SECTION 00913 - ADDENDUM NUMBER 3

- 1.01 DATE: June 3, 2013
- 1.02 PROJECT: UNIVERSITY OF SOUTH CAROLINA - COKER 7TH FLOOR PHARMACY RENOVATIONS
- 1.03 PROJECT NUMBER: State Project #H27-6101, A/E #12023.01
- 1.04 OWNER: University of South Carolina
- 1.05 ARCHITECT: GMK Associates, Inc.
- TO: PROSPECTIVE BIDDERS
- 2.01 This Addendum forms a part of the Contract Documents and modifies the Bidding Documents dated April 23, 2013, and Addendum Number 1 issued May 22, 2013, and Addendum Number 2 issued May 28, 2013 with amendments and additions noted below.
- 2.02 Acknowledge receipt of this Addendum in the space provided in the Bid Form. Failure to do so may disqualify the Bidder.
- 2.03 This Addendum consists of 3 pages and the following attachments:
- A. SECTION 02080 - ASBESTOS ABATEMENT (FME CONSULTANTS)
 - B. SECTION 11531 - LABORATORY FUME HOODS
 - C. DRAWING M1.7
 - D. DRAWING AB-1 (FME CONSULTANTS)

UNIVERSITY OF SOUTH CAROLINA
COKER- 7TH FLOOR PHARMACY RENOVATIONS
COLUMBIA, SC

STATE PROJECT # H27-6101
A/E PROJECT # 12023.01

5.04 DRAWING AB-1 (FME CONSULTANTS)

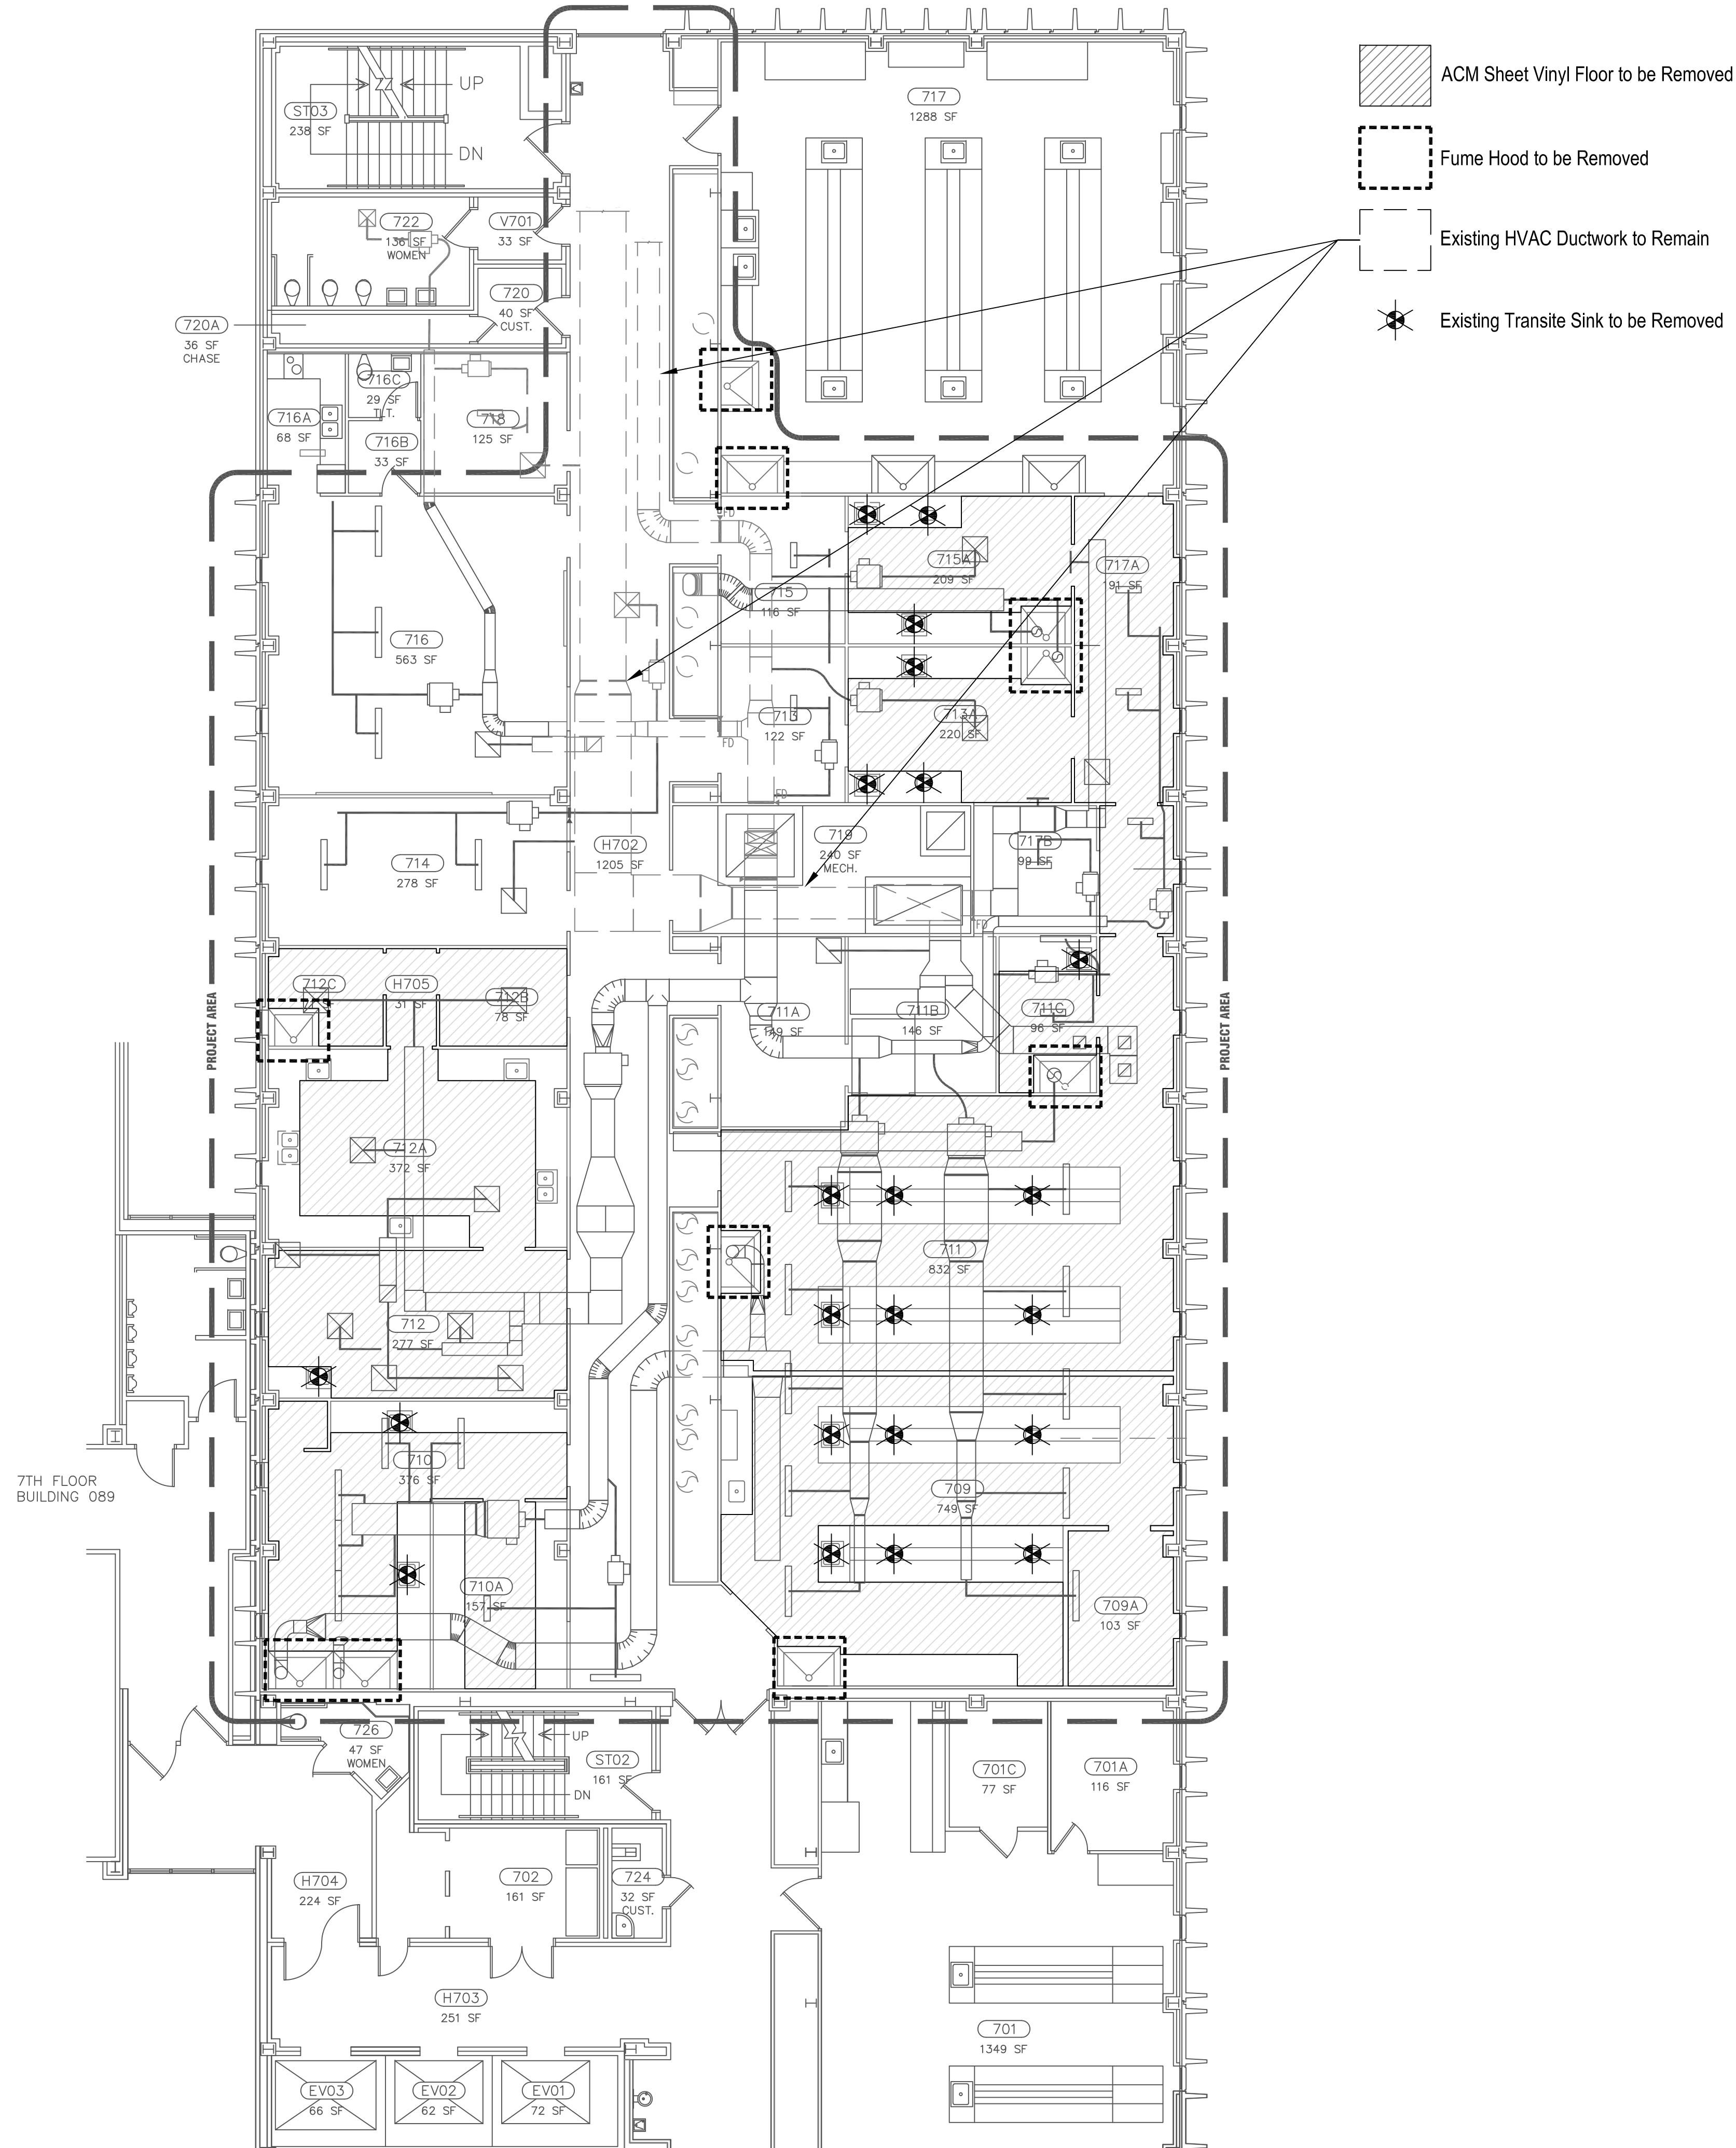
The following is a summary of the scope of abatement activities required during the abatement operations. More detailed information regarding materials, execution, etc. are provided in other sections herein and abatement plan AB-1. Please note that the mechanical systems shown on plan AB-1 are a general schematic depiction of the existing HVAC components.

- Fume hoods found throughout the project area are lined with Transite panels. Fume hoods shown to be removed shall be dismantled so as to access these panels for removal and disposal as ACM. Methods utilized to remove Transite panels shall not damage them. Removal of screws shall be deemed a friable abatement without a negative exposure assessment which must be submitted to the Owner and Owners representative for approval prior to the start of the abatement.
